Panel & FC interface

DELTA LIST OVER PREVIOUS PINOUT RELEASED ON :

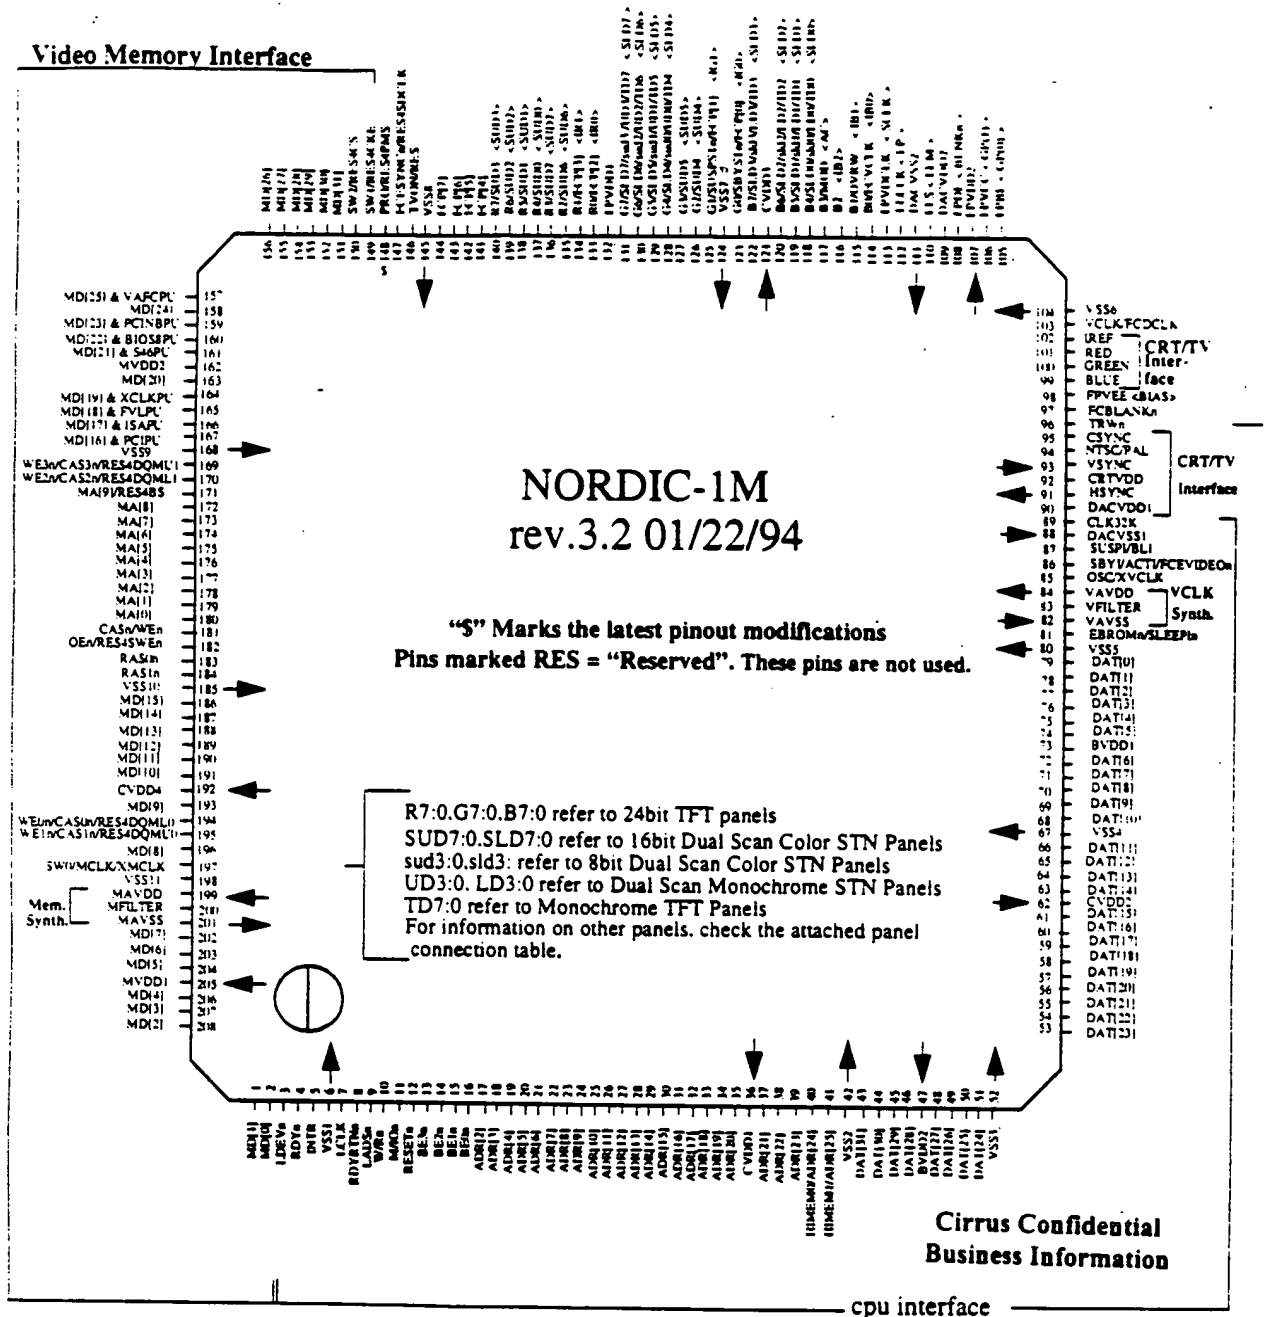
- no POUT on SW2/POUT
- XVCLK moved from SW1/VCLK/XVCLK to OSC/XVCLK. This way SW1/VCLK/XVCLK became SW1/VCLK.

- All panel pins whose names were not starting with the color panel name were changed such that the names start now with the color panel pin (R7, G7, B7 and so on). So it was only a pin name change.

1. Took-out Whisper Support Pins: WWRn, WRdn, WAD[3:0], FPCn.
2. Reduced the number of CPU Address Pins: ADR[24:27] went-away. Use HIMEM to place the chip outside 16MB of memory for linear addressing.

3. Killed CRTVDD and placed CRT Interface on Host Bus VDD.
4. Introduced VAFC pins in a unique pinout configuration in both VESA VL and PCI.
Added VAFCPU a pull-up to enable VAFC (VESA Advanced Feature Connector).
ADR[27:24] become VAFC pins. and R[7:4], G[7:6], CLK32K, SUSPI/BLI, SBYI/ACTI get a configuration for VAFC -> total 14 pins.
SW0/VCLK will be used as VAFC DCLK. losing SW0 pin as panel type when VAFCPU is used.
In PCI bus, no ADR pin will be shared with VAFC.
ASW0PU will be added on MD pins to replace SW0 pin when VAFC is enabled by VAFCPU. SW0PU will read-back in the same register bit as SW0, so the BIOS will not feel any modification in the reporting scheme.
The chip will draw more power in suspend with VAFC.

5. Moved SW2, SW1/MCLK/XMCLK, the two RESERVED pins and TRWn on MVDD to prepare for SDRAM pin compatible option in the next Nordic that supports SDRAMs. It looks that we need only 3 more memory pins to support SDRAM-s so TRWn will not be used. It was moved so it is on the right VDD bus if needed.

6. Moved CVDD3, VSS3, VCLK Synth, H/VSYNC, EROMn, SW0 per Thomas Hung's request to fit the floor plan.

1. Added AUXS1 on D/Cn as an option to be used with CS4231S as CS.
2. Added AUXS2 on EROMn/VADRn as an option to be used for Sound Synthesizer Chip Select.
3. Rearranged 5428 FC pins due to a previous error : R5 and R4 should not be used with FC.
 - FCP[1:0] are shared with G7 and G6.
 - SW2 and the two pins reserved for SDRAM were moved in between Video Memory pins and Panel pins and one of them is used as FCESYNcn.
 - OVRW is shared with CLK32K, FCBLANKn is shared with SUSPI and FCEVIDEn is on SBYI.
4. Renamed the External Clock PU XCLKPU instead of XMCPU.

1. Moved some external pull-ups.
2. Added alternate pin functions on panel pins as well as actual schematic name for engineering

1. Added TV-OUT (called also NTSC-OUT) pins on the panel pins

1. Added TVG on EBROMn/AUXS2 and took out VADR as an option on this pin.
2. Put back FCESYNcn on RES4SDCLK as an option (deleted by mistake).

1. Reset became RESETn, active L to correspond with the defined reset signal for VESA VL and PCI.
2. TFT Panels Data Pins R7:R0, G7:G0, B7:B0 changed and all pins got rotated to get them ordered from right to left. Due to this change now Ri=TVRi, Gi=TVGi and Bi=TVBi.

1. Update Panel Data Pins based on Robin's Table.
2. Move MOD pin on a Panel Data Pin used in 18bit TFT.
3. Move OVRW on a 24bit Panel Data Pin.
4. Removed pin configuration for TV-OUT support with digital encoders. All pins marked TV... were removed. As a result, some pins like LLCLK, LFS, FPDE, FPDCLK have one function now.

5. Removed WavePort pins, including AUDVDD: total 7 pins freed.
AUX2 and TVG muxed on EBROMn are no longer needed either.
6. Added one more CPU address pin: instead of HIMEM, Nordic has now HIMEM0 and HIMEM1, corresponding to CPU Address 24 and 25 or any other external decode of the high order CPU address bits. In the process of adding this pin, most CPU Interface pins on the right side were moved to the right by one pin.

7. Added CRTVDD supplying HSYNC, VSYNC, CSYNC, NTSC/PAL CRT and TV Interfaces output buffers.
8. EBROMn is shared with TVON, the power-on signal for AD720. So, in ISA bus with on chip BIOS support, AD720 power on cannot be directly controlled by Nordic.

9. Added pins for Analog TV Encoder support - AD720 and MC1377 :
 - a. CSYNC = Composite Sync signal
 - b. NTSC/PAL = 1 -> NTSC, 0 -> PAL (for AD720, but it is TV Encoder Dependent)

- c. EBROMn/TVON (see #8).
10. ASW0PU "Alternate Switch 0 Pull-Up" pull-up on pin 155. MD[26] was removed, as SW0 is now not multiplexed.
11. De-multiplexed some of the pins previously multiplexed:

- a. Pin 168 TWRn/RES4PMS is now RES4PMS, a pin reserved for synchronous DRAM support.
 - b. SUSPI/BLI/FCBLANKn is now SUSPI/BLI, not affected by the Feature Connector Enable Configuration

- c. As a consequence of b, pin 97 is FCBLANKn (not muxed with anything). Please note that FCEVIDEOn is still muxed with SBYI/ACTI as before, as Standby Input and Keyboard Activity are less important functions in a system.

- d. SW0 is no longer muxed on VCLK/FCCLK. So VCLK/FCCLK is a pin but it moved to pin 103 in the PVDD area, to be consistent with FC power supply.
12. SW1, muxed on MCLK/XMCLK (pin197) became SW0. This is just a name change to have the switches placed in a more consistent manner.

13. SW1 is now muxed with a reserved pin: RES4CKE, pin 148, which before was totally reserved. The idea here is to go for pu/pd with SDRAM-s for SW2 and SW1, while keeping SW0 on MCLK even with SDRAM-s.
14. Pin 147 is Reserved. It is actually one of the WavePort pins, but placed in-between Memory and Panel VDD busses (on MVDD) for maximum flexibility. To achieve this, the pins on its right were moved to the right by one FPVDD <BIAS> moved down to pin 98 (it was 105).
15. TRWn is now by itself on pin 96, on FPVDD.
16. The names of all flat panel data pins reflect the panel type table attached to this document.

1. On EBROMn/TVON -> EBROMn/SLEEPIn with SLEEPIn an input which if L puts Nordic to sleep (as 3C3[0] and 46E8(3).
2. TVON is now on RES, but TVON/RES is pin 146 and FCESYNCh/RES4SDCLK is pin 147.

1. Pin 148, RES4PMS which was a pin reserved for synchronous DRAM-s, got a function: it is now a programmable output PRO and it is on FPVDD instead of MVDD. The intention is to optionally use this pin to control a switch between 5V and 3.3V, in which case a H level of 5V is desirable. My primary choice for this function is actually NTSC/PAL pin which is on CRTVDD, but if the TV-OUT option is used in a system and a switch between 5 and 3.3V is provided, PRO may be used.
